STAFF REPORT

AGENDA ITEM: Royal Golf Club at Lake Elmo 3rd Addition Final Plat and Planned Unit Development (PUD) Plans and Easement Vacation

REVIEWED BY: Ken Roberts, Planning Director
Jack Griffin, City Engineer

Updated Final Plat

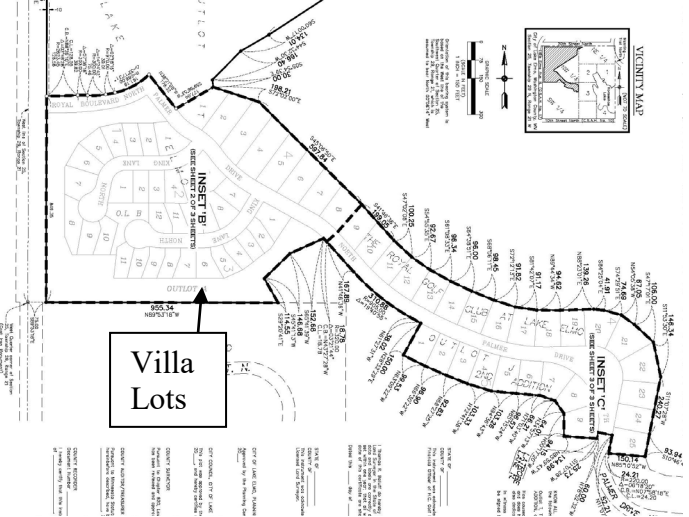
Consistency with Preliminary Plat. The proposed lot sizes, widths, and proposed impervious surface are generally consistent with that of preliminary plat. The only change is the modification of Kings Lane which was shown as a loop road in the Preliminary Plat, and is now proposed as two cul-de-sacs in the Final Plat. As a result of the conversion to two cul-de-sacs, forty original villa lots fronting Kings Lane have been reduced to 33 villa lots. General circulation is maintained in the broader development with through-traffic along Palmer Drive.

Street Design. As shown on the 3rd Addition Final Plat the Applicant has proposed to reconfigure the 'loop' road and instead develop two cul-de-sacs to serve the lots within the 3rd Addition. Both cul-de-sacs as shown meet the City's ordinance requirements for cul-de-sac length, required right-of-way and cul-de-sac terminus. This change is generally consistent with the lot types shown on the Preliminary Plat and the cul-de-sacs do not change the character of the Plat.

SIGN / PAVEMENT MARKING / LIGHTING PLAN

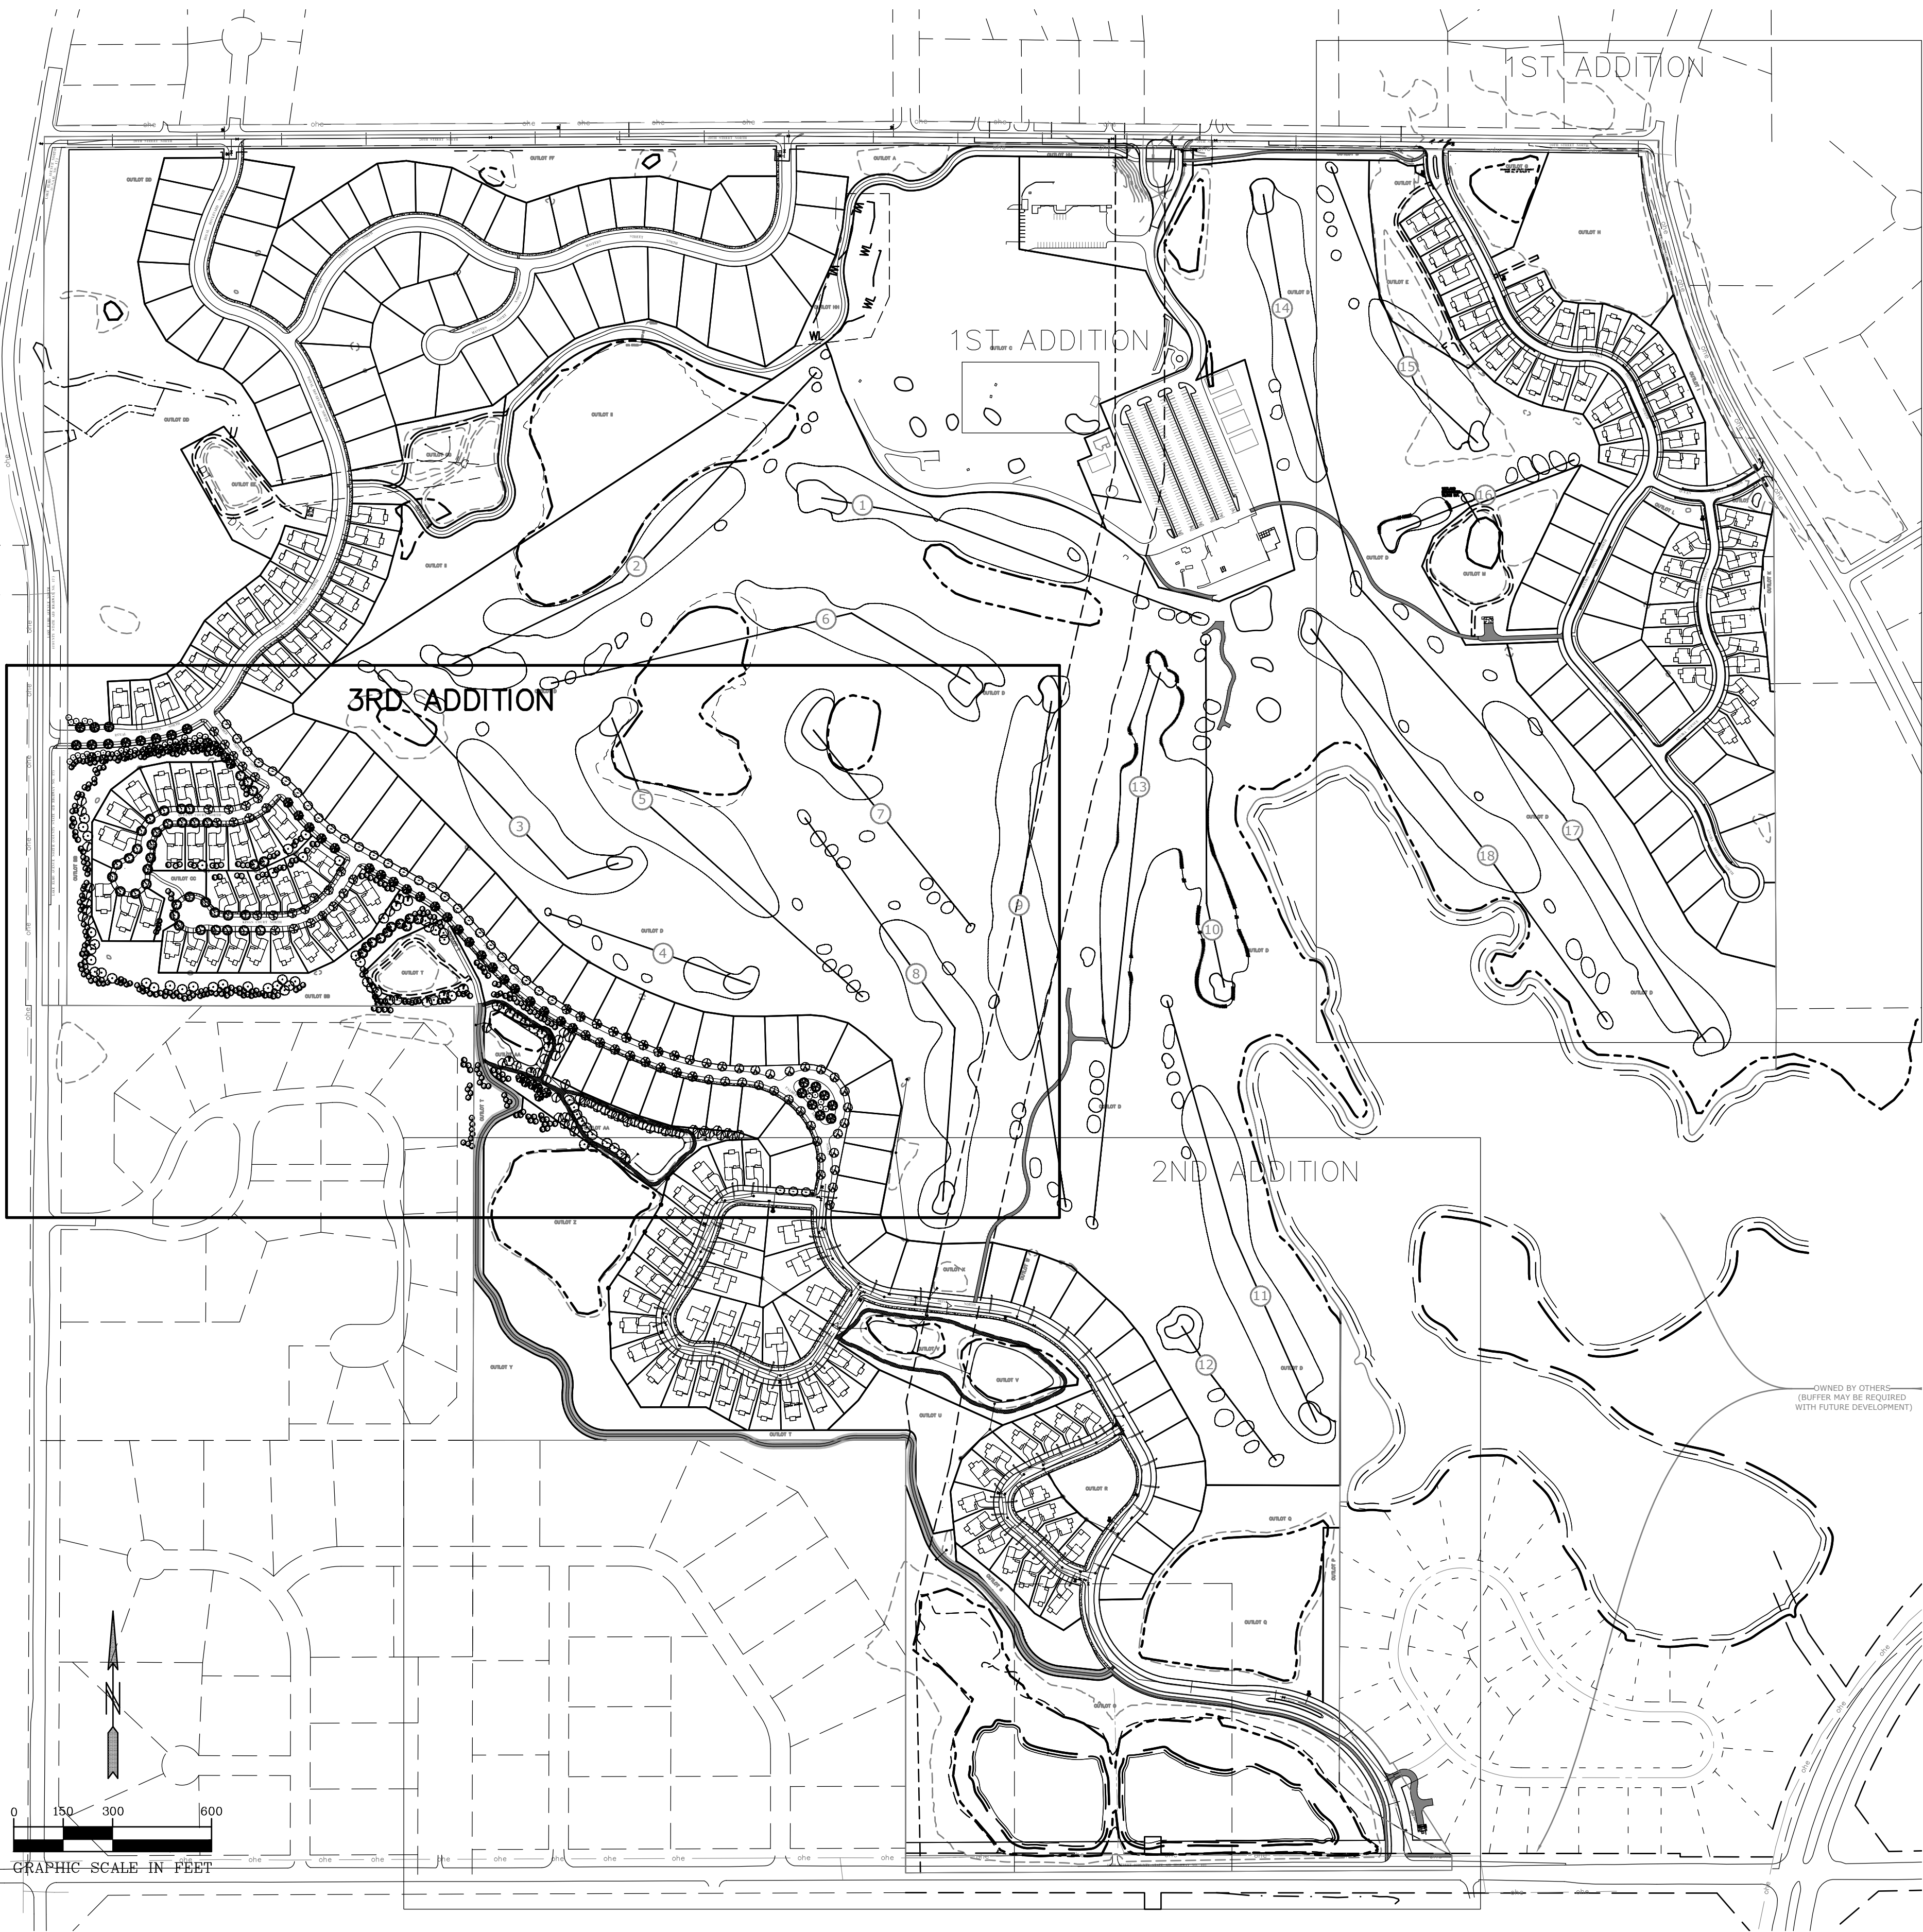
- Sheet 18. Remove one light pole from the Palmer Drive eyebrow and relocate the second light pole to the middle of the two eyebrow intersections.
- Sheet 18. Add no parking signs to the interior of the Palmer Drive eye brow (3-signs).
- Sheet 18. Add no parking signs to the sign schedule.
- Sheet 19. Add no parking signs to the Kings Court and Queens Court cul-de-sacs (3-signs each).
- Sheet 19. Add a stop bar at the intersection of Lake Elmo Avenue and Royal Boulevard.

L3

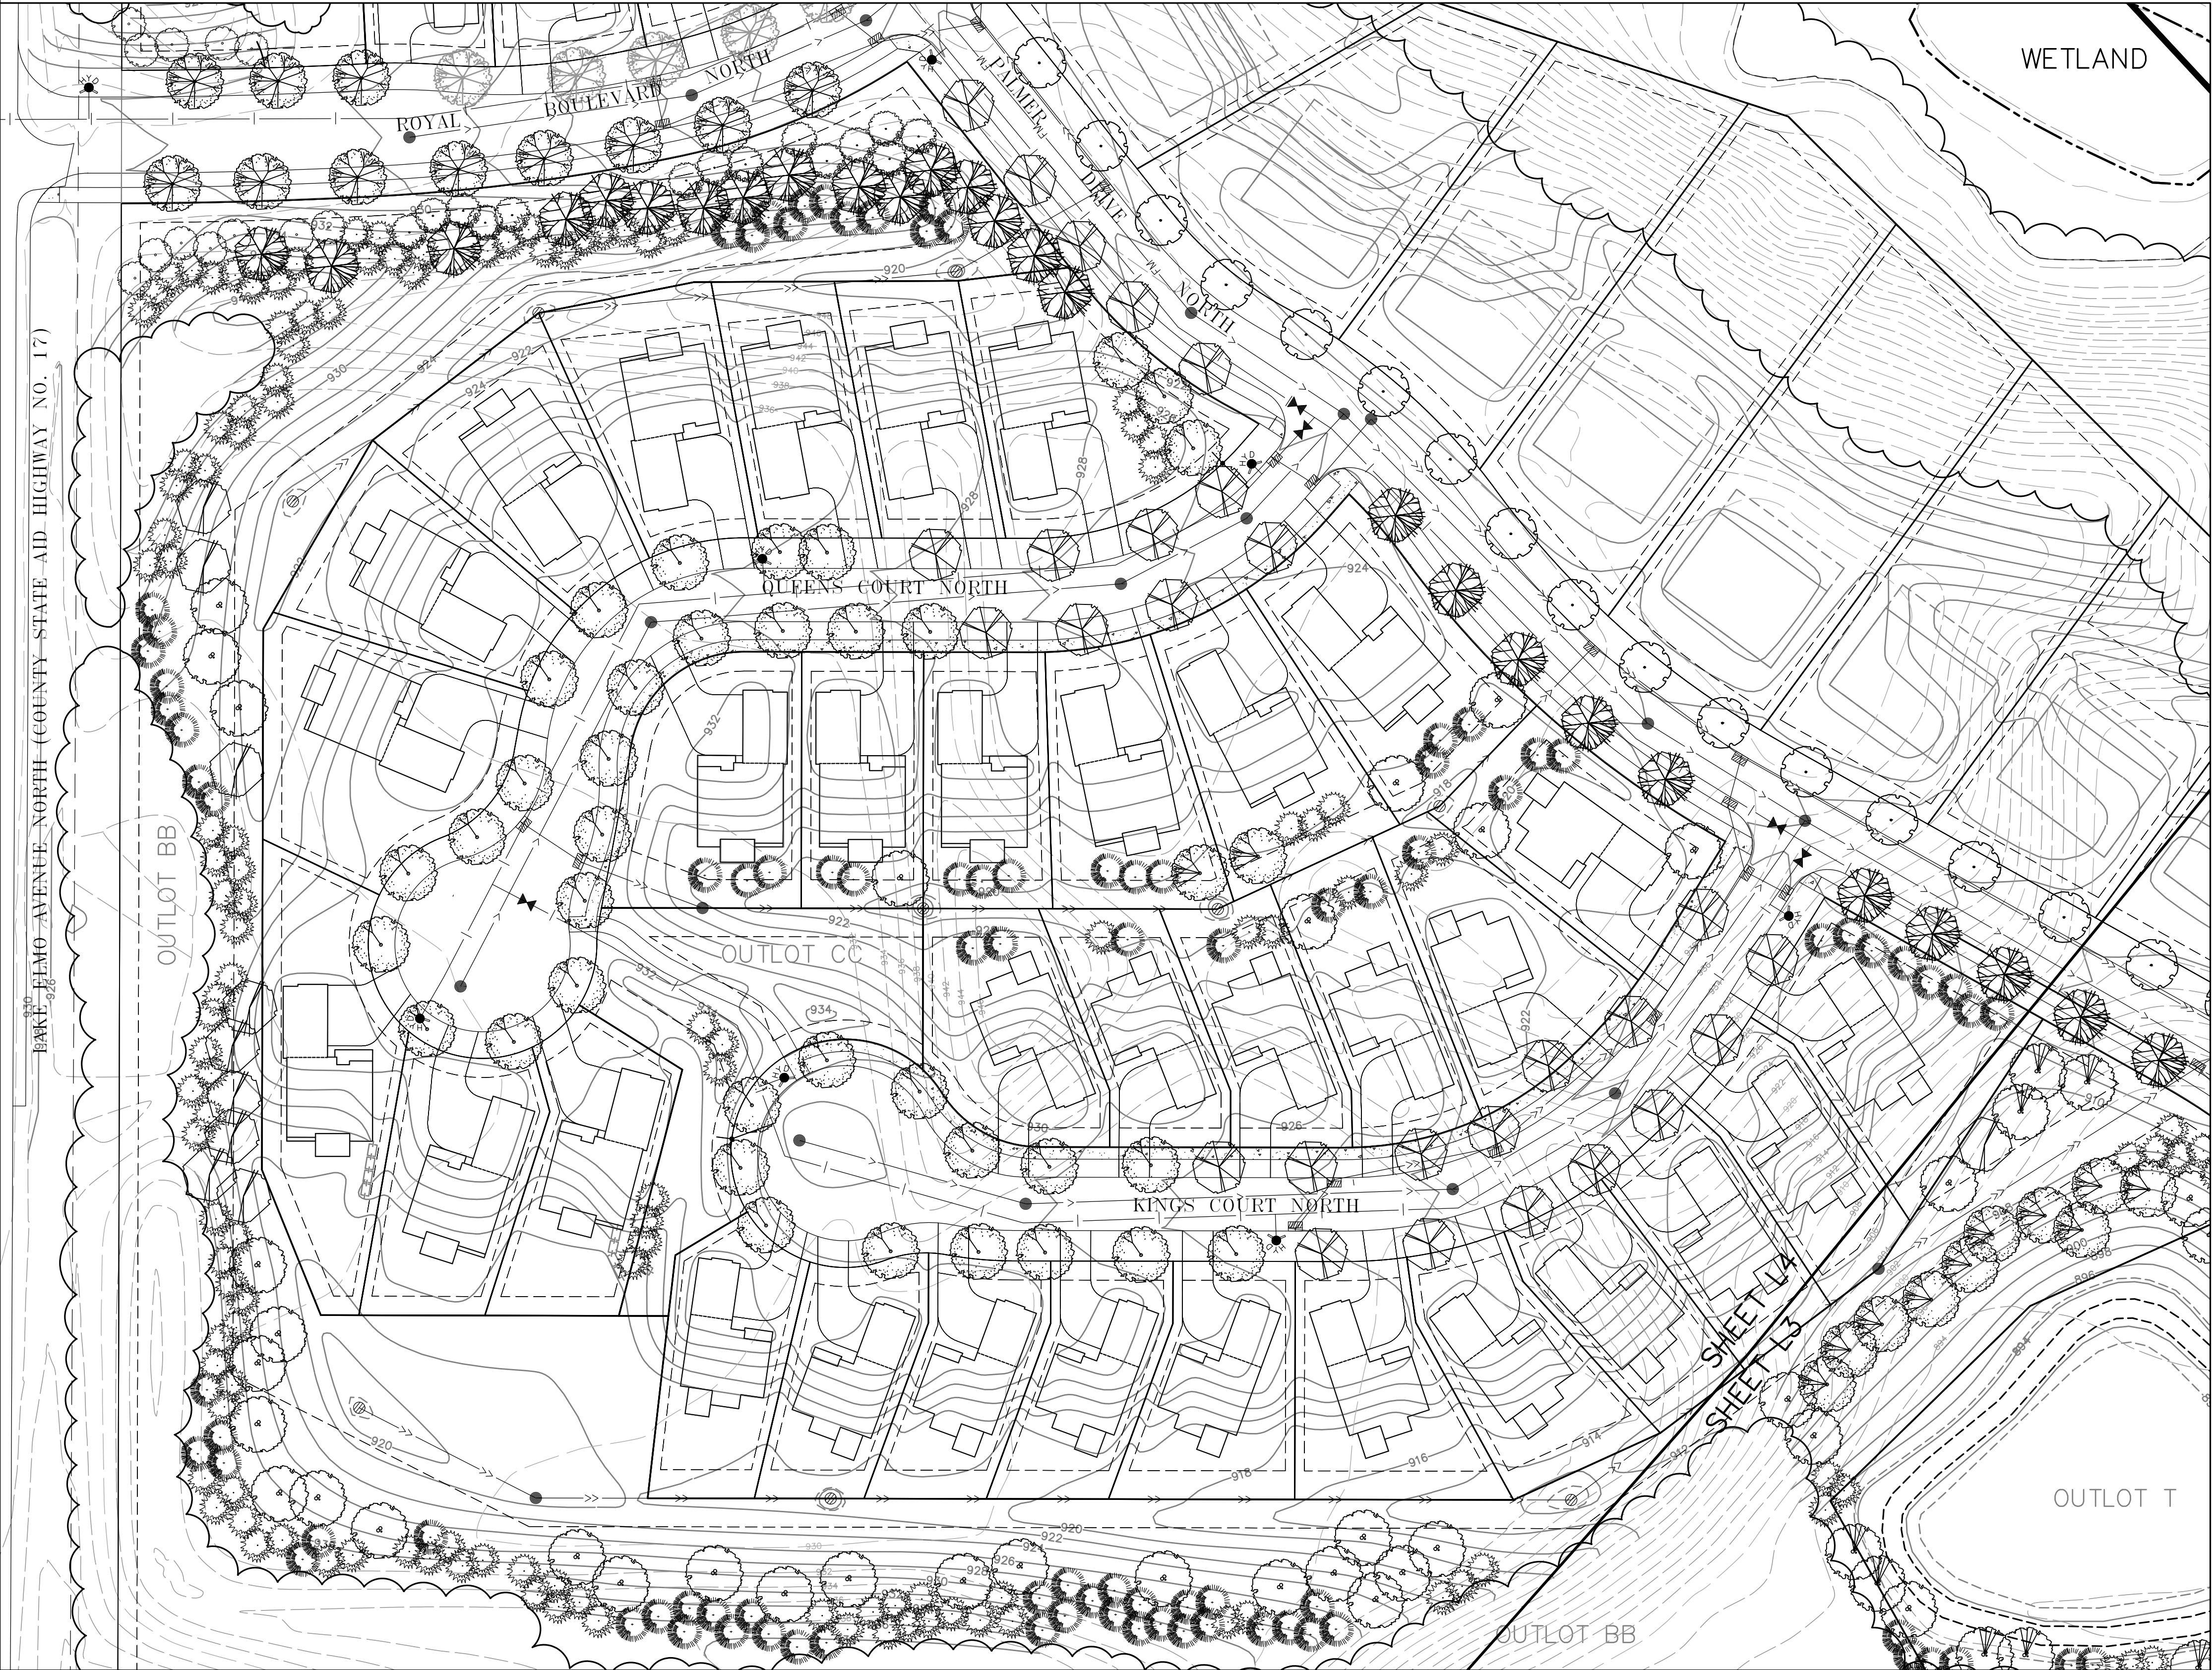
Landscaping. The developer has provided landscaping plans for the 3rd Addition, which are attached hereto. The City's Landscape Architect has reviewed the landscape plans and has recommended approval with the condition of adjusting the location of trees noted on sheet L4 that will overlap proposed buildings and drive locations when mature.

17. The location and spacing of the trees that overlap the buildings and on edge of driveway when shown at mature diameter is adjusted and resubmitted on a revised landscape plan, per the Landscape Review memo, dated November 8, 2018.
